SUBJECT
Cullompton Model Updates 2016 / 2017

OUR REF
0008-UA005763-BM-03

PROJECT NUMBER
UA005763

This memo summarises the updates made to the River Culm and tributaries hydraulic model. The hydraulic model has been used to inform the Flood Risk Assessment for the Cullompton Eastern Relief Road and Proposed New Southern Bridge/Proposed Junction 28A (M5) (the Scheme).

Figure 3-1 2d_fcsh and SRF Factor Derivation

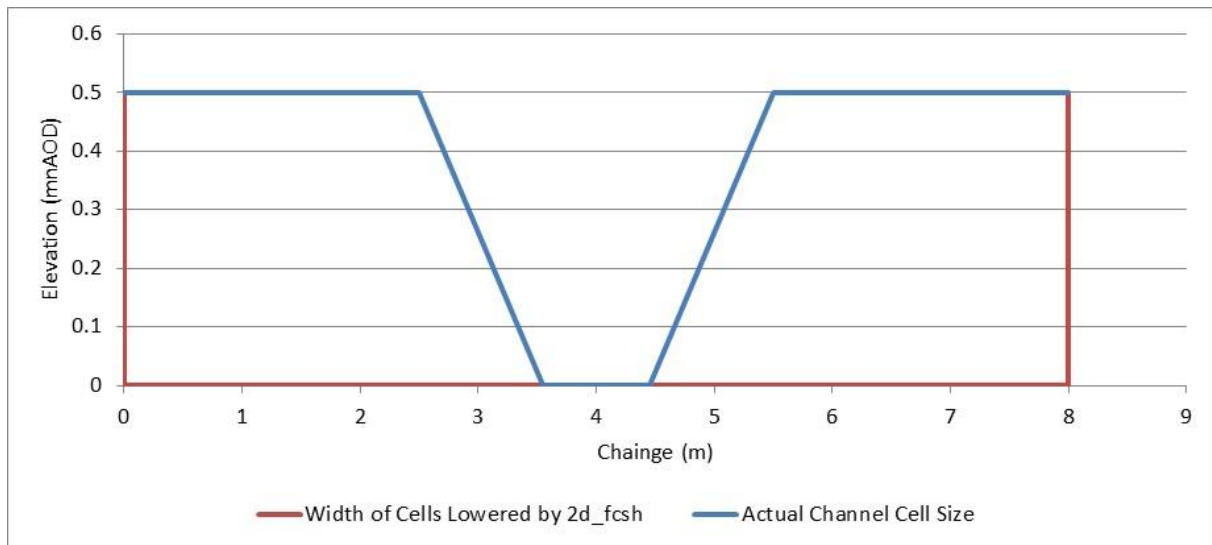
Issue: Clarification was required regarding the derivation of the SRF and pBlockage factors used in the 2d_fcsh and 2d_SRF layers.

Resolution: The pBlockage value is a function of the channel width (determined using the LiDAR) and the grid cell size. A 'Shape_width_or_dMax' value of 8 is used in order to apply the 2d_fcsh to two cells. This ensures that a constant line of adjoining grid cells, side to side, are lowered, allowing water to flow through each cell, and avoids cells on a diagonal being selected, which stops water flowing through the cells. Figure 3-1 shows how the 2d_fcsh lowers a width of 8m, two 4m grid cells in this case giving a cross sectional area of 4m². However, the cross sectional area of the channel in this example is 0.98m² giving a pBlockage value of 76%. The SRF factor allows the storage of the cell to be reduced in conjunction with blockage of the conveyance.

Figure 4-2 Floodplain Culverts (Contains Ordnance Survey data © Crown copyright and database right 2017)

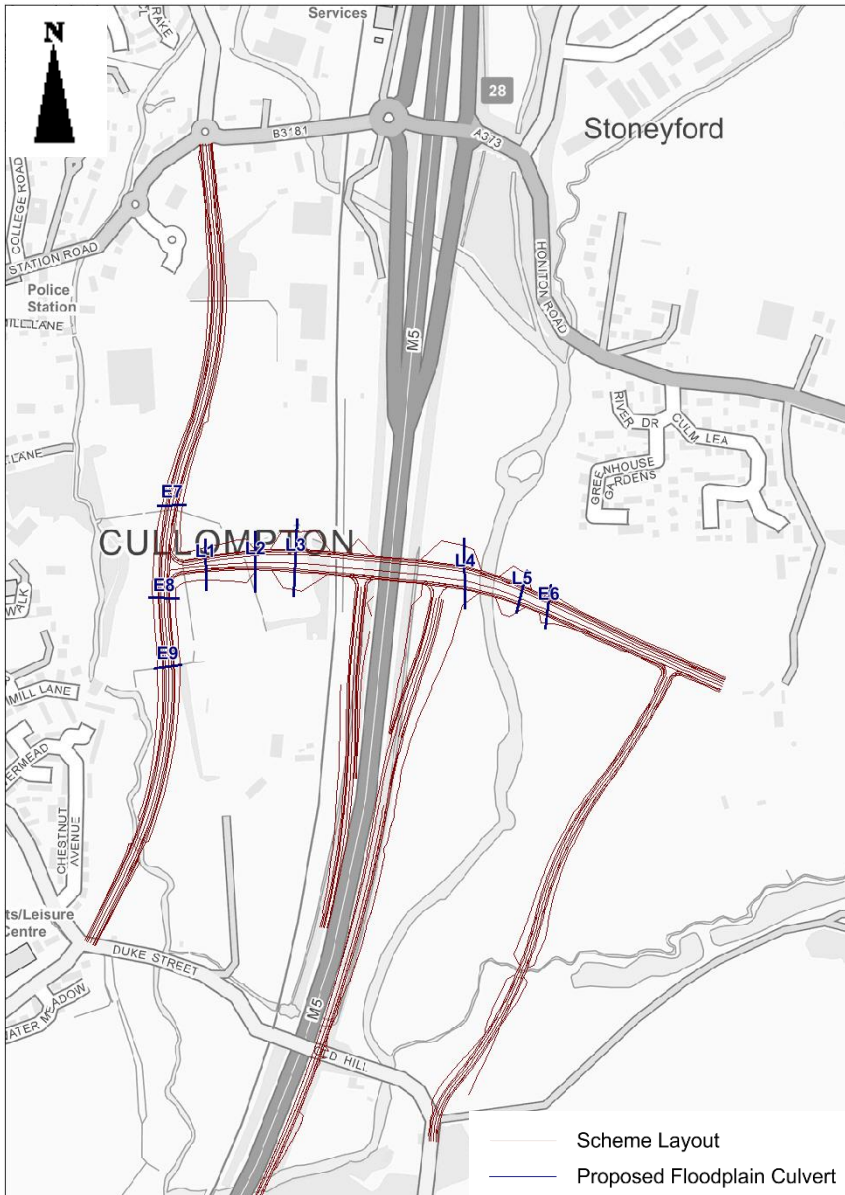
The EA 2016 Review requested an analysis of the change in water level (afflux) across the proposed floodplain culverts (Table 4-3).

Culvert L4 shows a large afflux for the lower flood events (5% and 2% AEP), which is due to some small differences in ground levels at the entrance and exit of the culvert where the lfcsh abuts the base DTM. Ground levels are very close to the peak stage for the smaller events and hence this difference is accentuated. Further optimisation of the culverts at detailed design stage will improve this. Results from the larger events show a much smaller afflux which is to be expected given the size of the culvert.

Culverts E8 and E9 are the smallest of all the floodplain culverts and pass a maximum of 0.02m³/s and 0.54m³/s, respectively. ESTRY results indicate that these culverts do not run full which may also suggest some scope for optimising levels and dimensions as part of the detailed design.

The negative afflux observed at culvert E9 suggests that there is scope for optimisation of this culvert, to improve flow conveyance as water levels are being maintained at a higher level on the area of floodplain between the north south link road to the west of the M5 and the M5 / railway line. Ideally, the culvert should allow water levels to equalise either side of the new road.

The sizes of the remaining crossings (L1, L2, L3, L4, L5, E6 and E7) have been maximised as far as practical within the constraints of the Scheme outline design and do not exhibit excessive afflux for the modelled events reviewed. However, the design of these crossings will be refined during the detailed design stage.
